Town of Kittery Planning Board Meeting April 8, 2021

459 U.S. Route 1—Major Modification Review to a Master Site Development Plan and Subdivision / Site Plan

Action: Accept or deny plan as complete; continue to a subsequent meeting; approve or deny plan; Pursuant to §16.10.9.3 *Modifications to approved plan* of the Town of Kittery Land and Use Development Code, owner/applicant Middlesex Land Holdings, LLC requests the review and consideration of a major modification to both an approved Master Site Development and Subdivision plan proposing to reduce the residential dwelling unit count from 44 (32 age-restricted; 12 non-age-restricted) to 32 (16 age-restricted; 16 non-age-restricted) dwelling units within 8 buildings and make associated improvements on real property with an address of 459 U.S. Route 1, Tax Map 60, Lot 24, in the Mixed-Use (MU) Zone.

1 FIRST FLOOR PLAN.
1/8" = 1'-0"

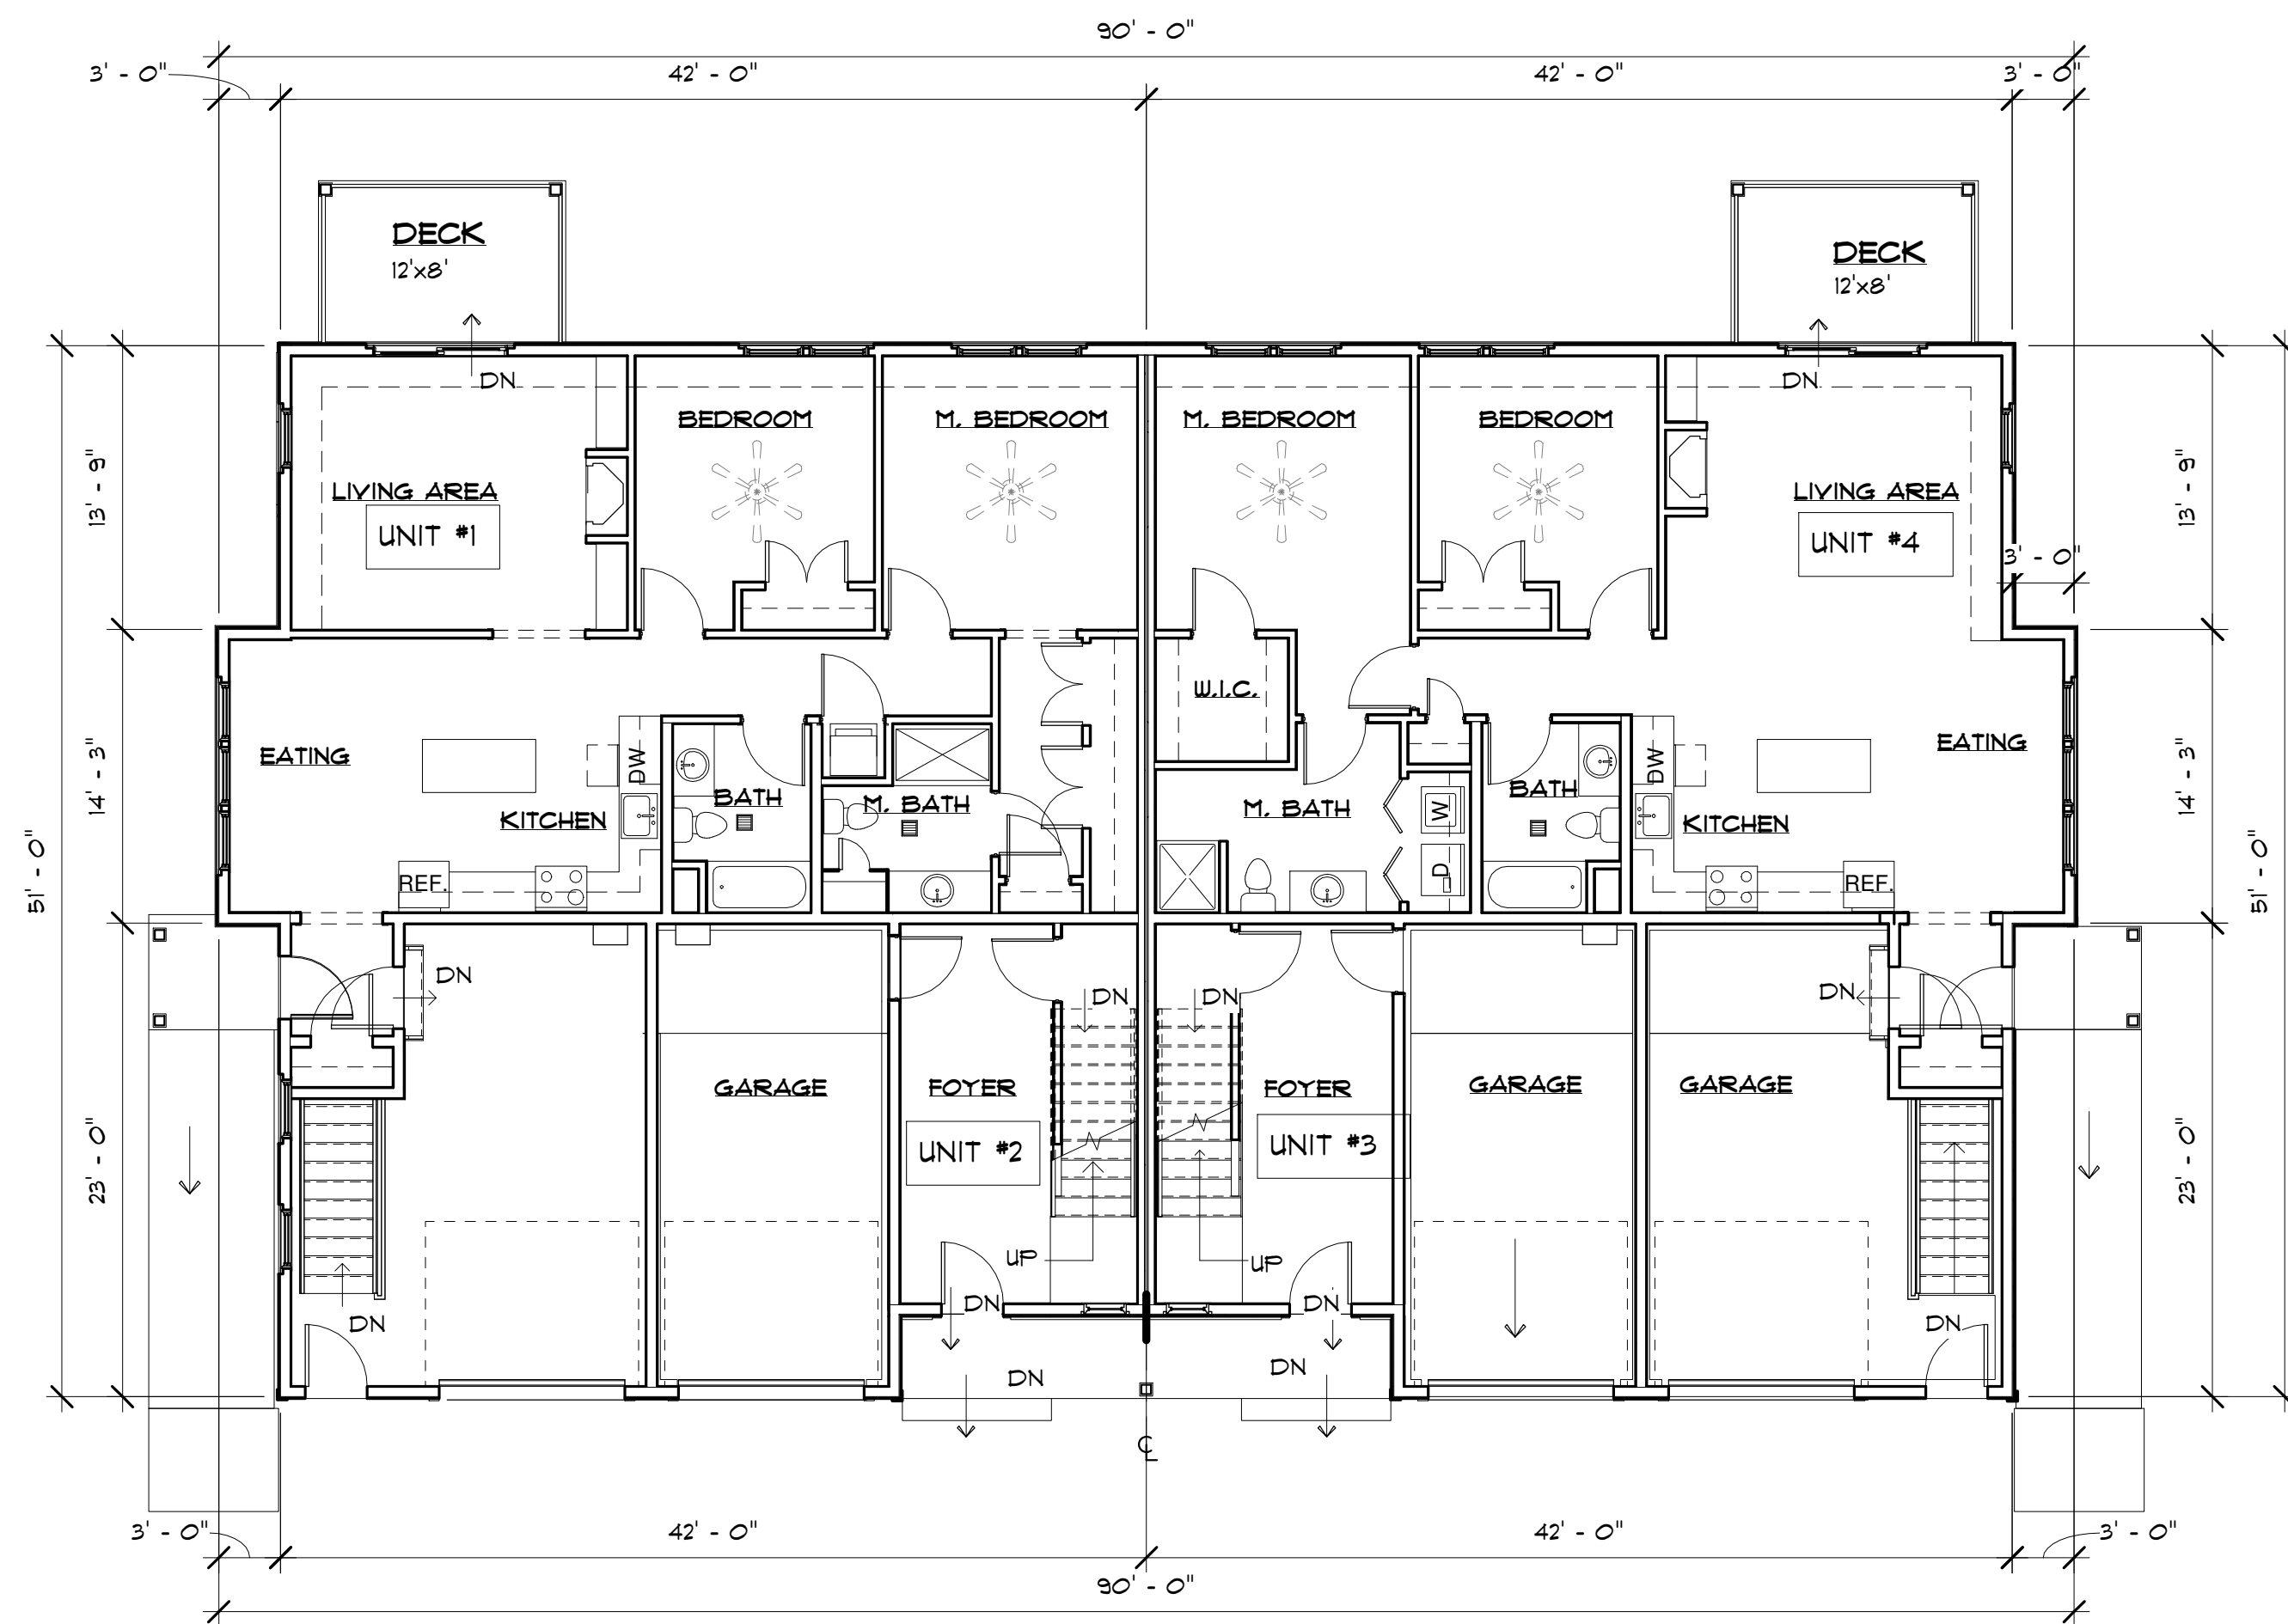
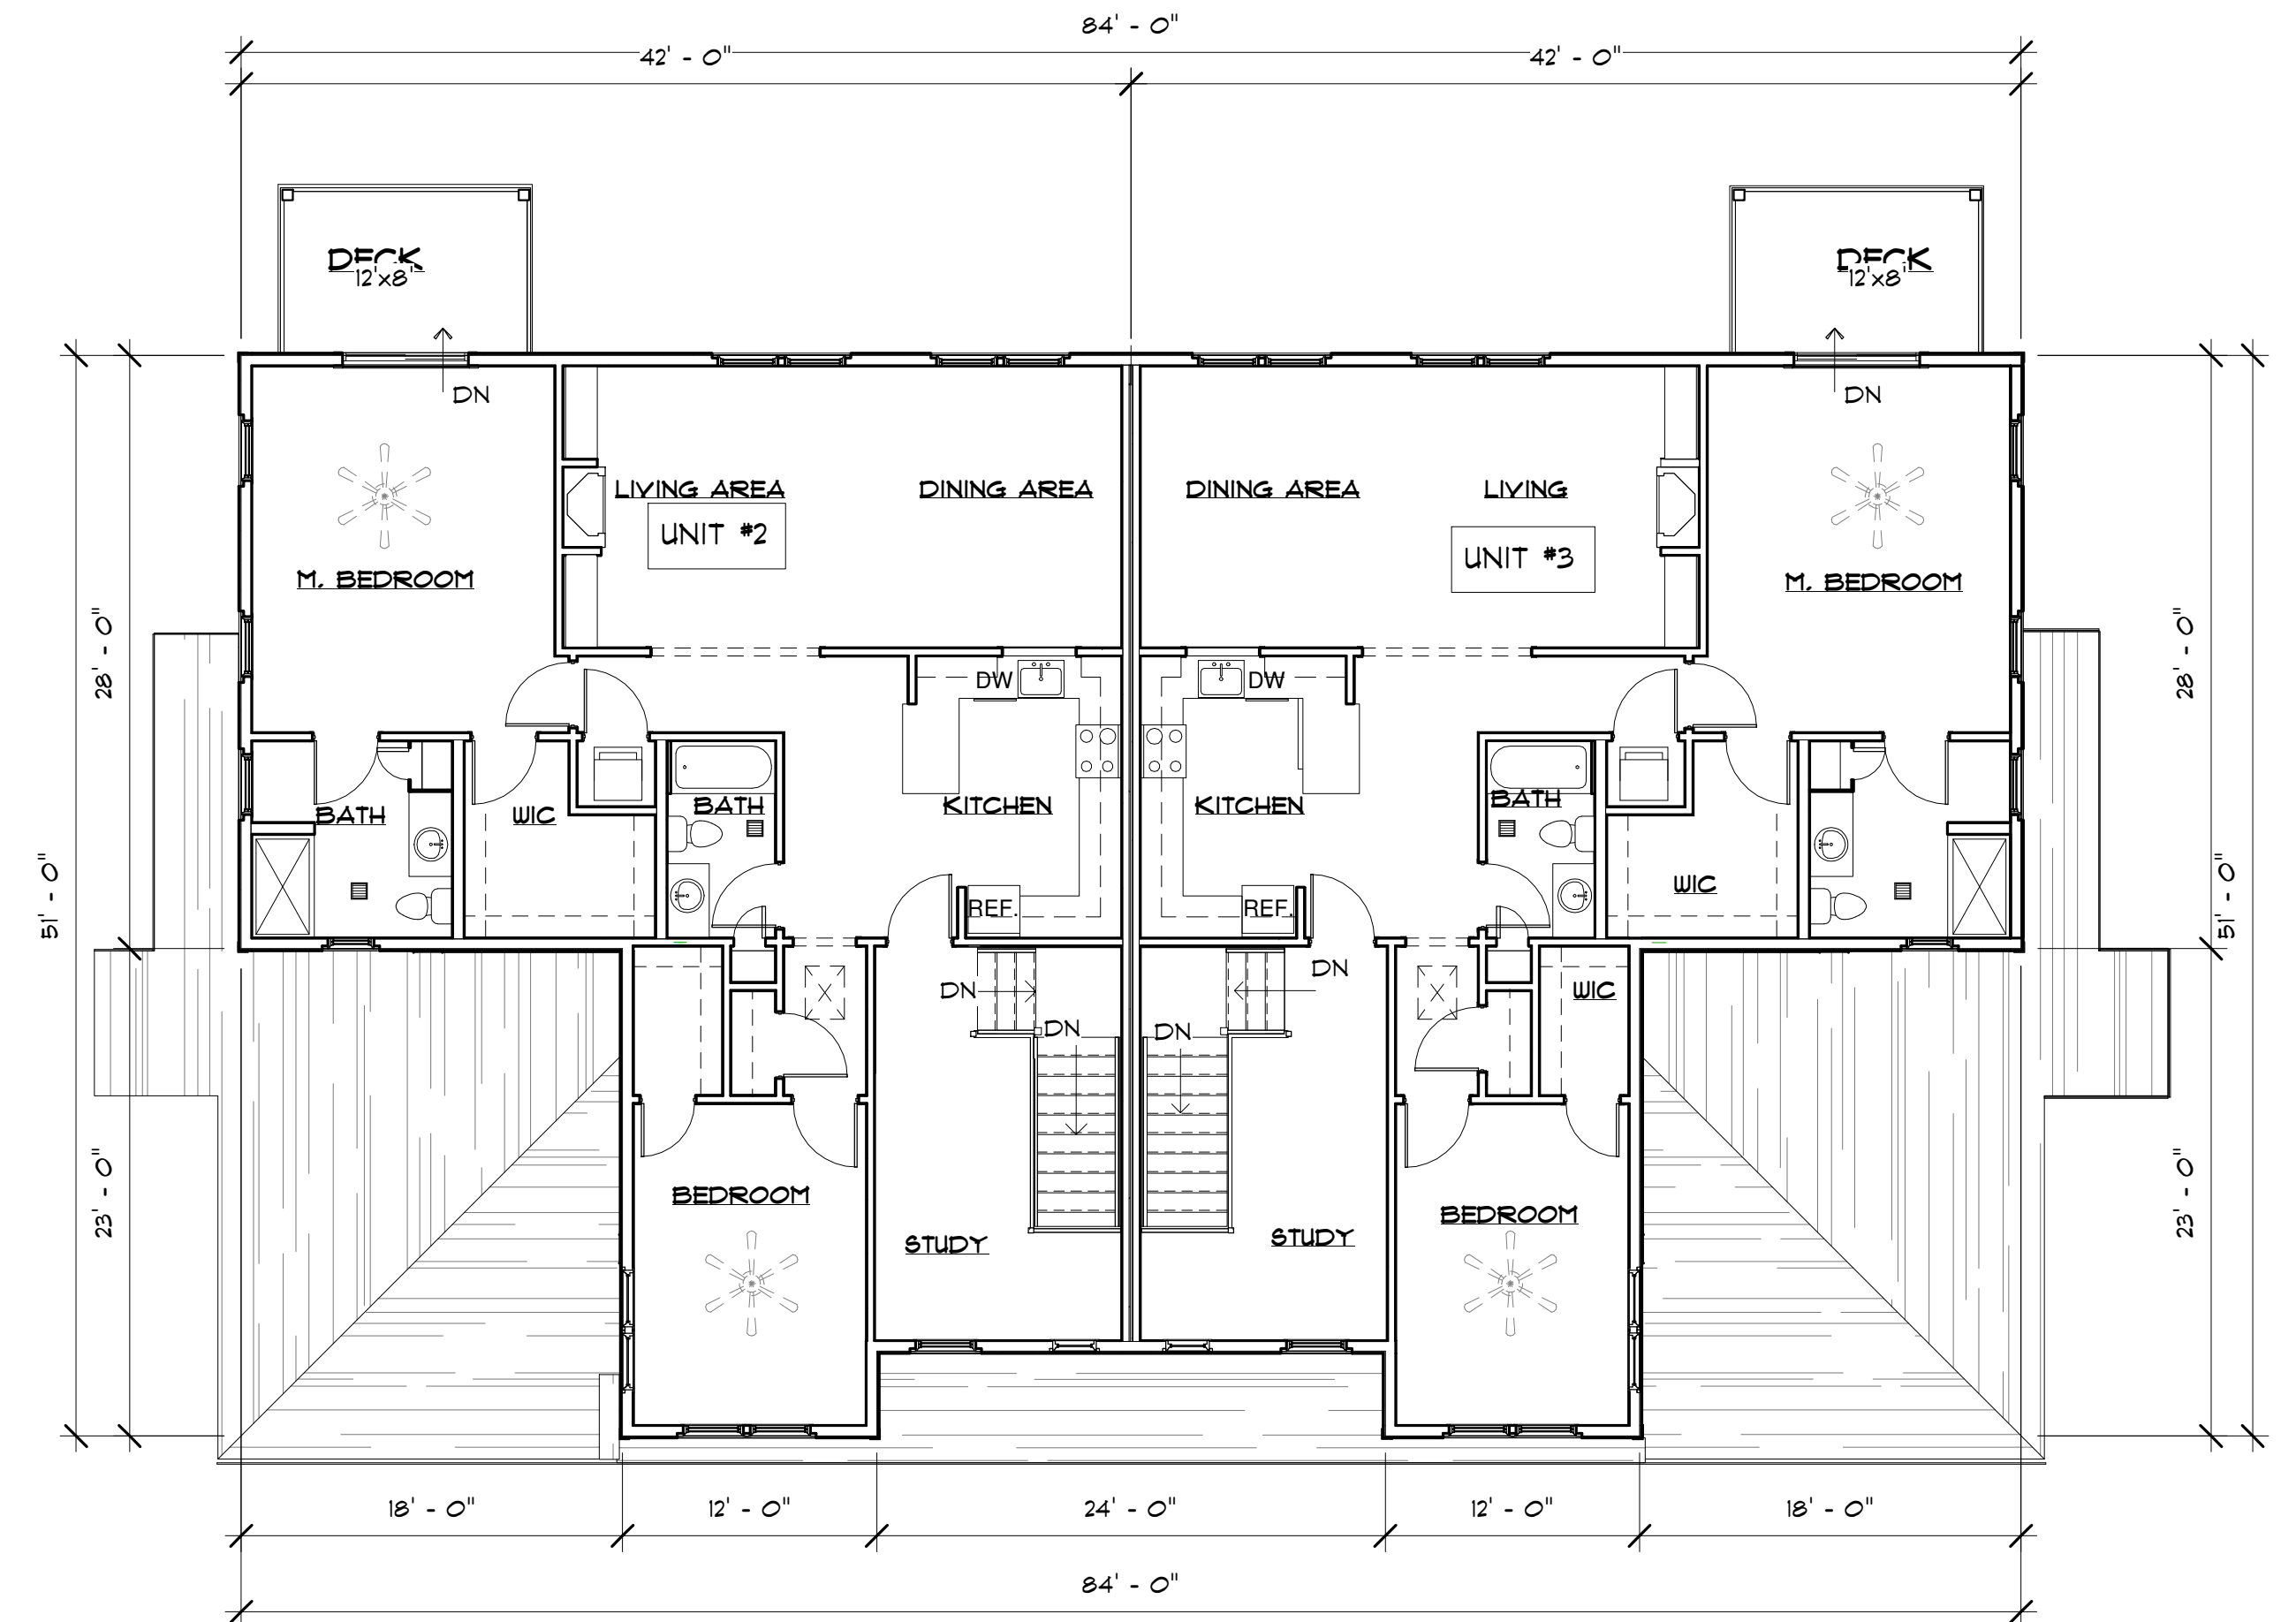
As stated previously, the architecture of the buildings is changing. It is unclear who will have access to the ground floor space of the perimeter buildings. The Board should have the applicant explain the layout of the new buildings to understand more precisely the areas of ownership. As for traffic volume, it appears the reduction of units corresponds with a decrease in vehicular volume, totaling 162 trips (dwelling units only) per day. This is a 28 trip reduction from the originally approved plan. A major element that appears to be missing from the plan are areas dedicated for snow storage, albeit Note 10 on sheet one states that all snow that cannot be stored in their designated locations will be trucked off site. The Board should have the applicant demonstrate their intended locations to determine adequacy of storage space.
